STAFF REPORT
COMMUNITY DEVELOPMENT DEPARTMENT

HEARING DATE: 6/16/2026
TO: Mayor & City Council
FROM: Sonya Allen, Associate Planner
208-884-5533
SUBJECT: Tanner Creek No. 2
FP-2026-0011
LOCATION: Generally located on the north side of I-84, 1/4 mile west of S. Meridian Rd., in the NE 1/4 of Section 13, T.3N., R.1W.

Final plat consisting of 76 buildable lots and 7 common lots on 10.65 acres in the R-8 and R-15 zoning districts. This is the second phase of Tanner Creek Subdivision.

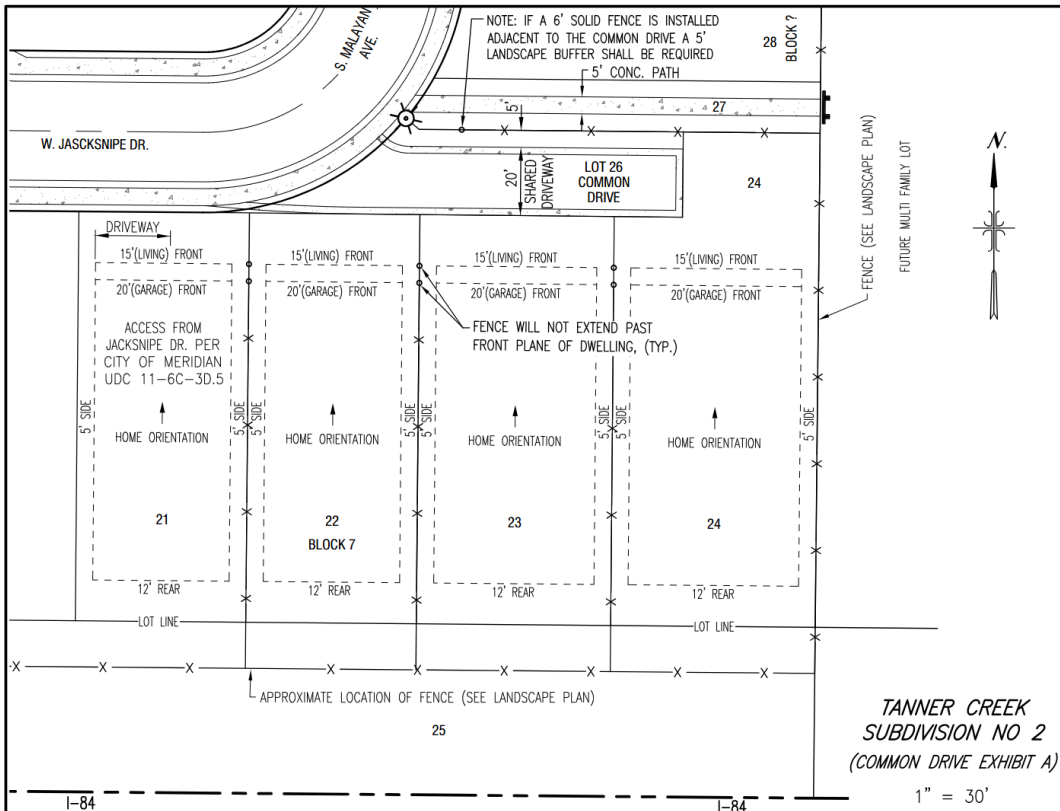
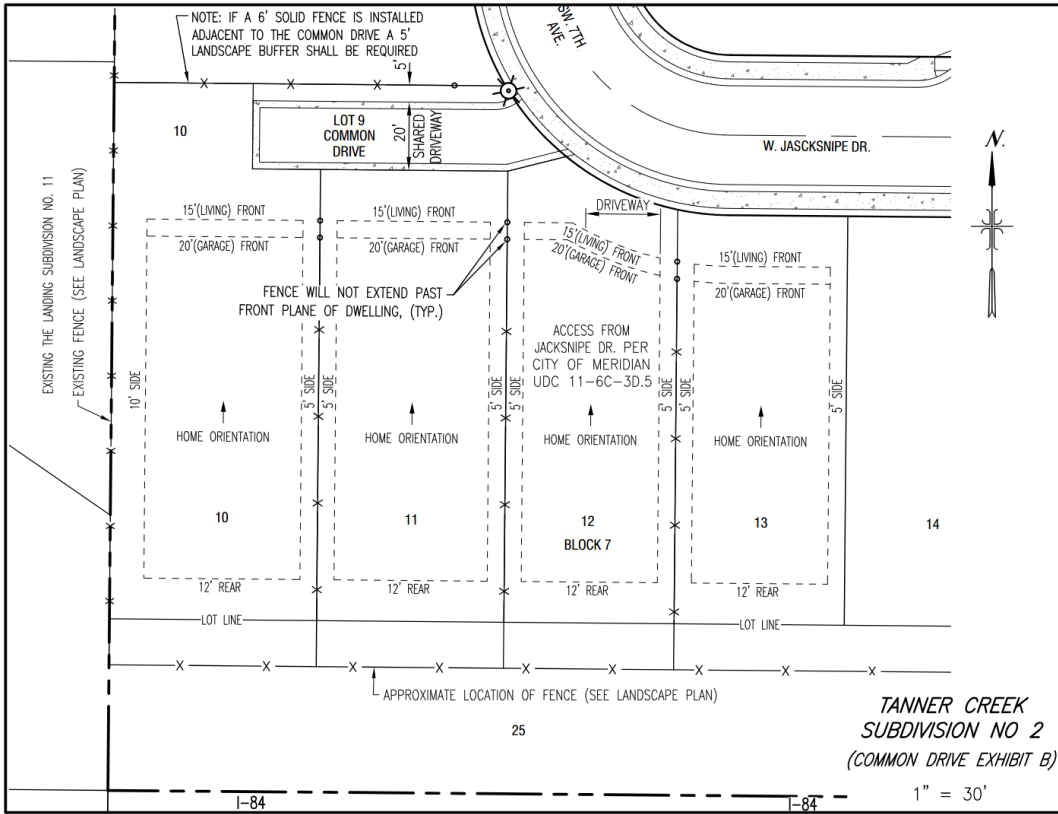
This phase of development was depicted as Phase 3 on the phasing plan approved with the preliminary plat. The development agreement (DA) allows flexibility in the phasing unless otherwise

restricted in the Cooperative DA with ACHD – the Applicant stated the proposed change to the phasing plan is allowed by ACHD. Therefore, Staff is amenable to the change.
